STAFF RECOMMENDATION

1236 Riverwood Drive

April 22, 2020

Application: New Construction—Addition
District: Eastdale Place Neighborhood Conservation Zoning Overlay
Council District: 7
Base Zoning: RS10
Map and Parcel Number: 06112016600
Applicant: Kim Kennedy, Bootstrap
Project Lead: Melissa Sajid, Melissa.sajid@nashville.gov

Figure 1. 1236 Riverwood Drive.

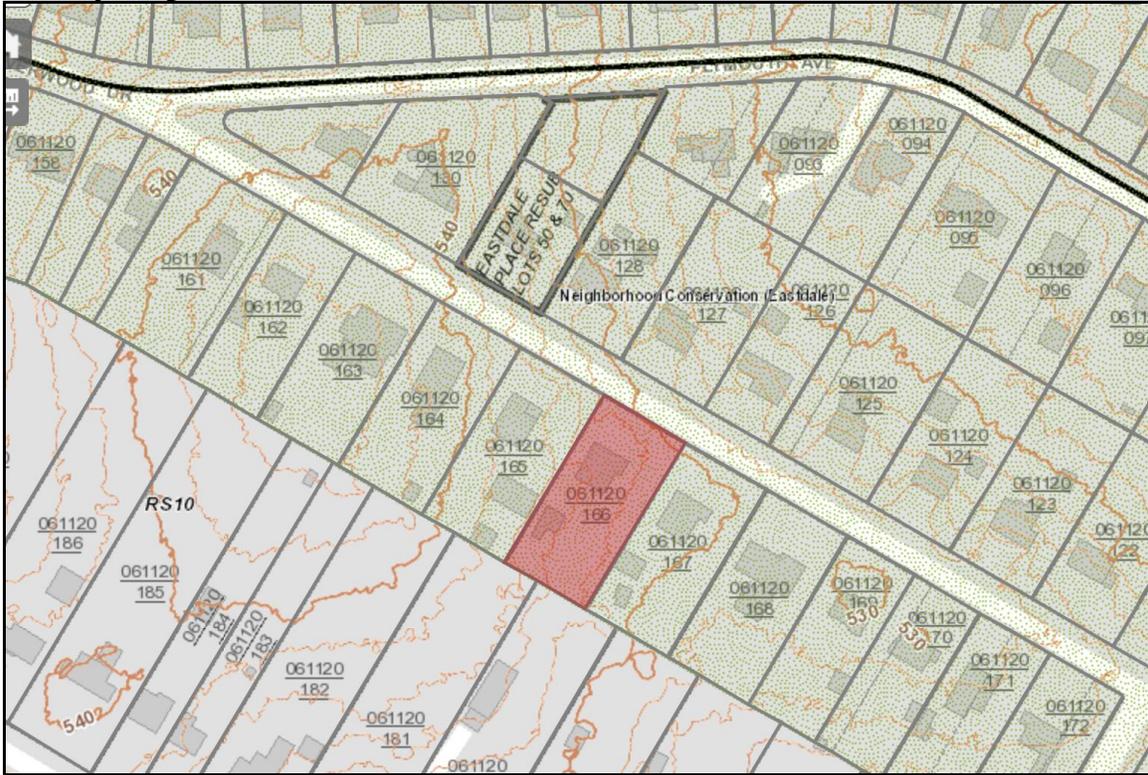
Background: The property located at 1236 Riverwood Drive is an English cottage that was constructed c. 1935 and contributes to the historic character of the Eastdale Place neighborhood (Figure 1).

SITE PLAN

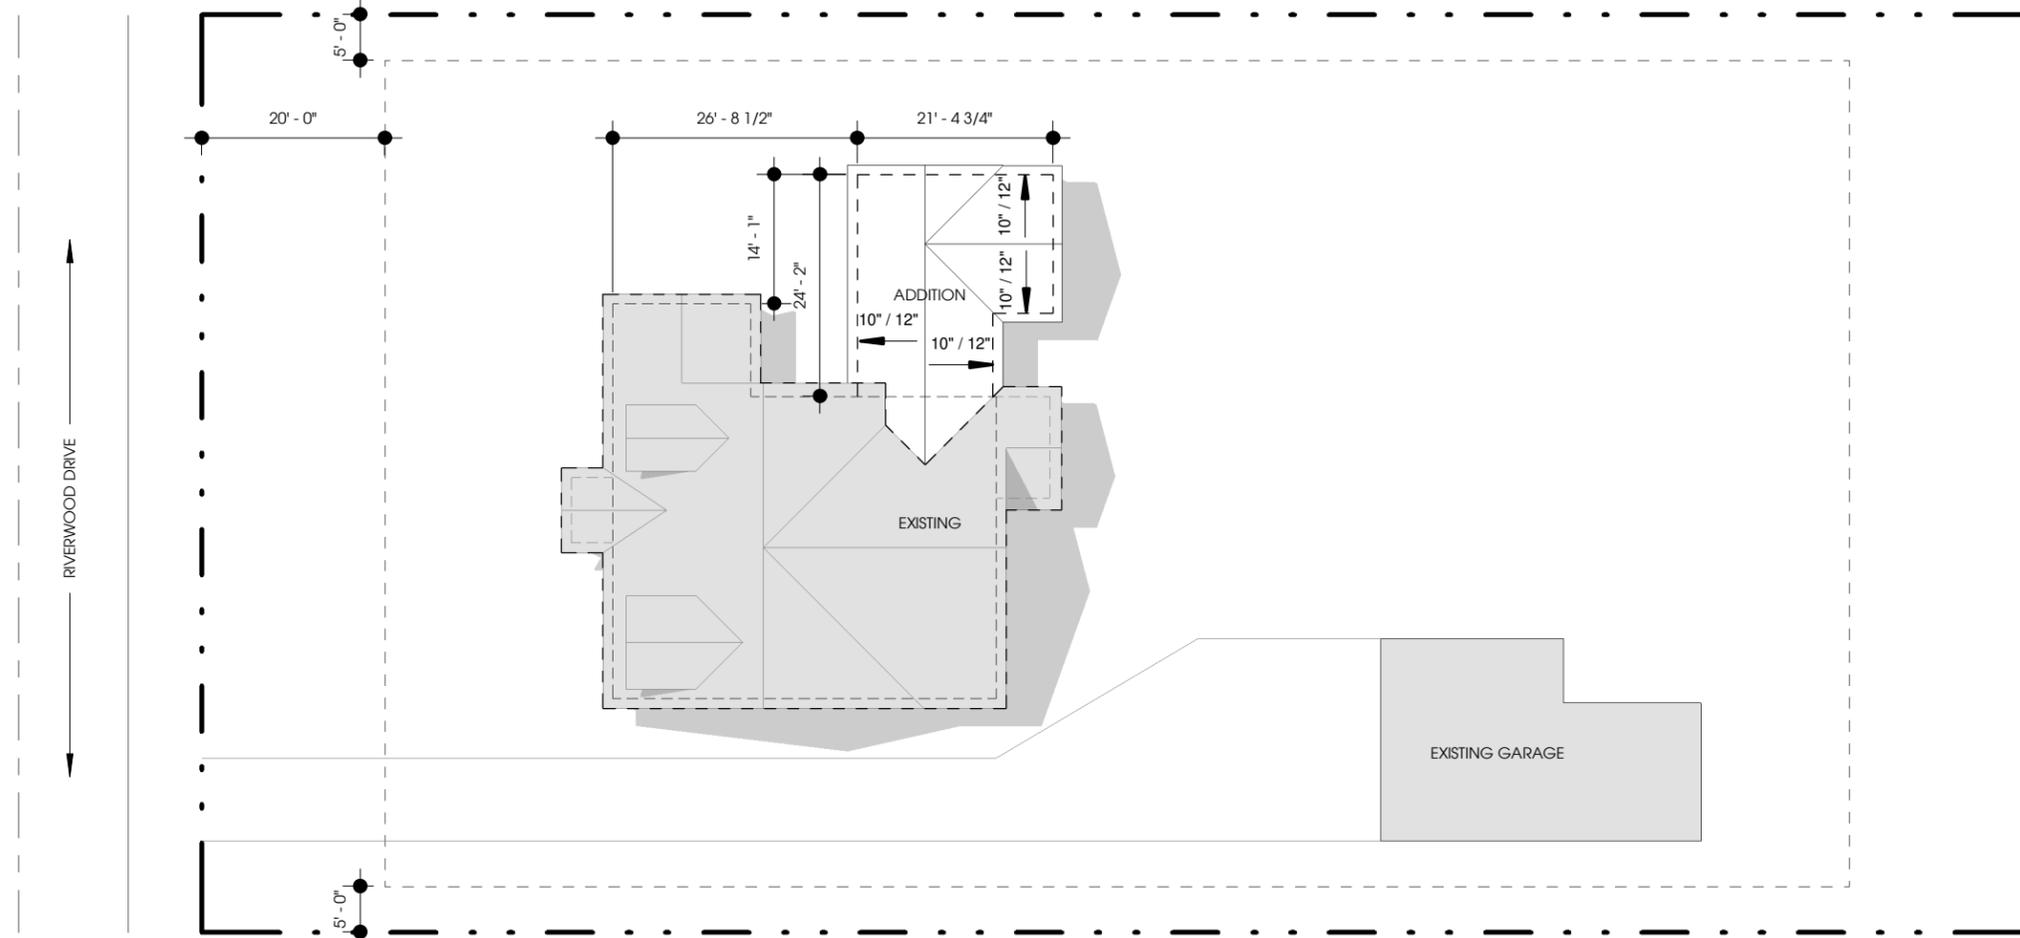
Setback & Rhythm of Spacing: The addition meets all base zoning setbacks as it is located approximately seventeen feet (17’) from the left-side property line and one hundred seven feet (107’) from the rear property line.

Staff finds that the project’s setback and rhythm of spacing meet Section III.C. of the Eastdale Place design guidelines.

ELEVATIONS

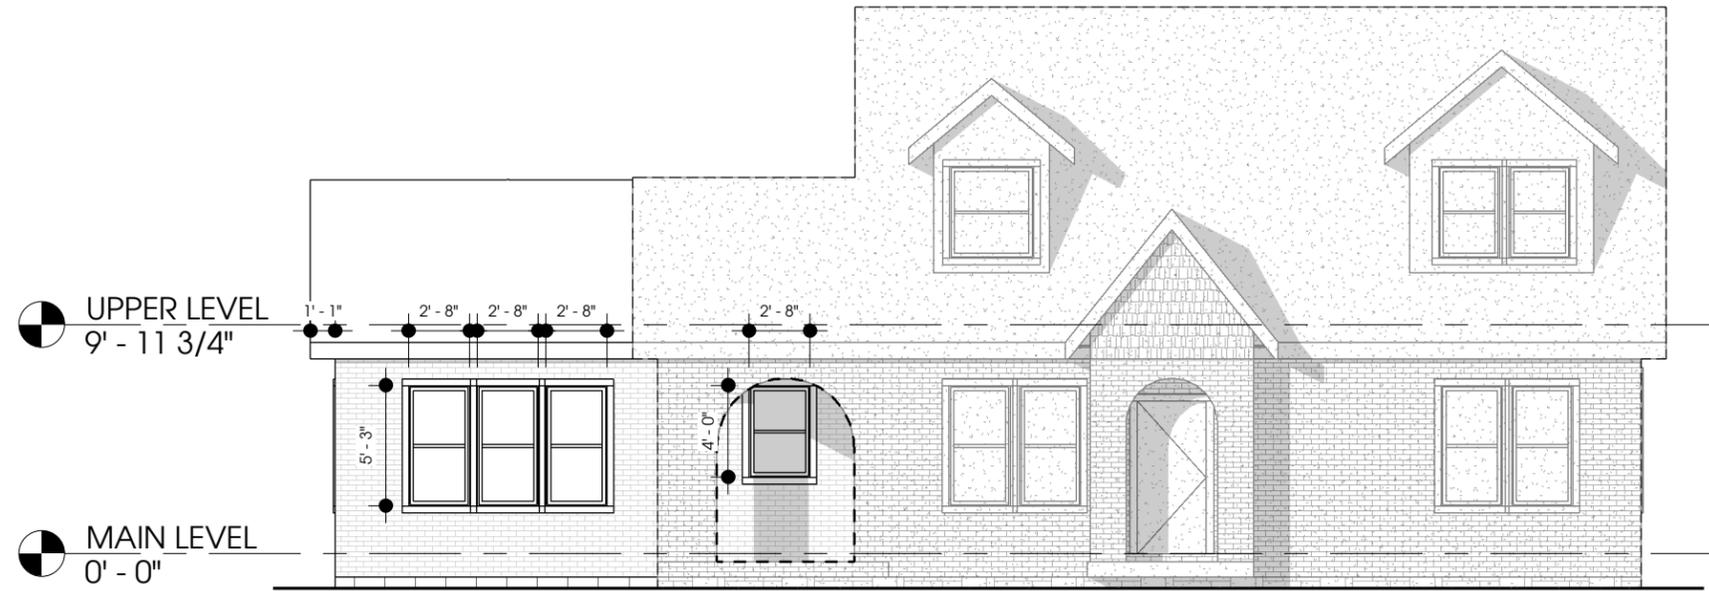
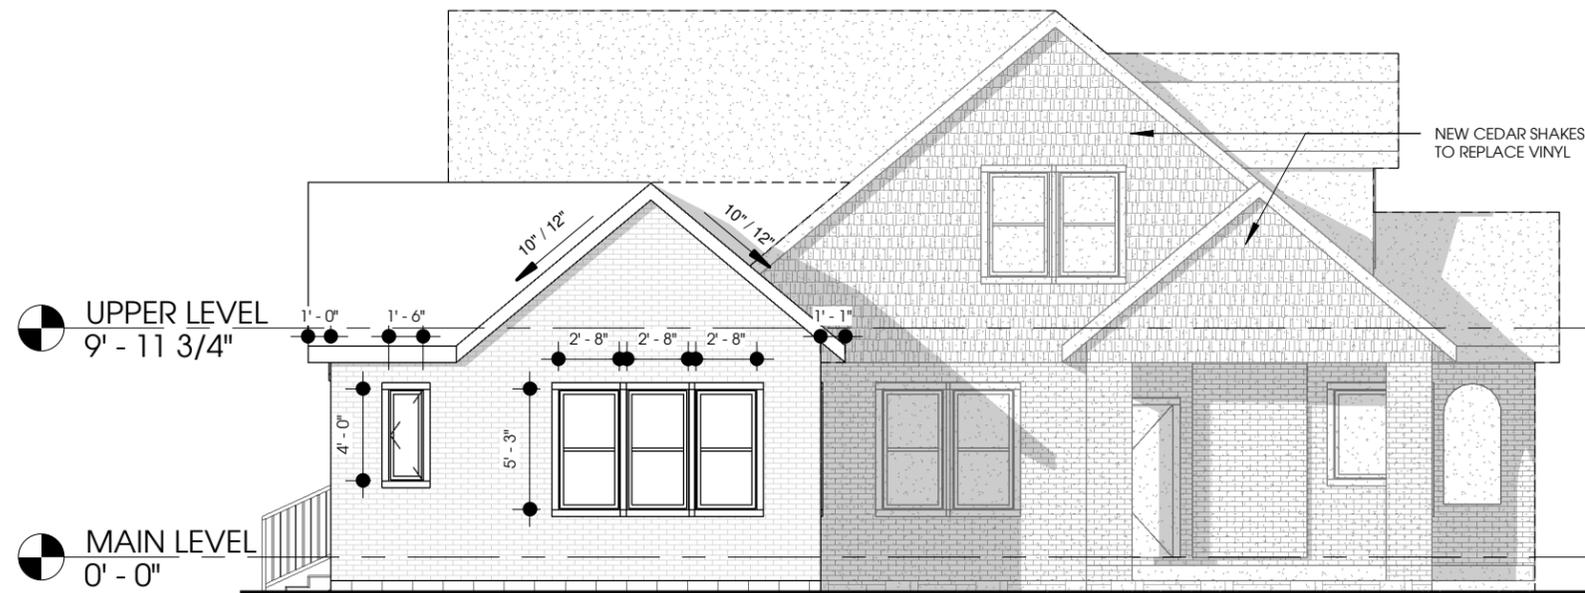
Roof form: The addition has a cross-gable roof form with a 10/12 pitch similar to that of the historic house. The roof will read as a side-gable form from the street which helps to deemphasize the massing of the side addition.

Proportion and Rhythm of Openings: No changes to the window and door openings on the existing house were indicated on the plans. The windows on the proposed addition are all generally twice as tall as they are wide, thereby meeting the historic proportions of openings. There are no large expanses of wall space without a window or door opening.

1. Staff approve the final details, dimensions and materials of windows and rear porch posts and railing prior to purchase and installation; and,
2. The HVAC shall be located behind the house or on either side, beyond the mid-point of the house; and
3. Staff approve the roof color and masonry color, dimensions and texture.
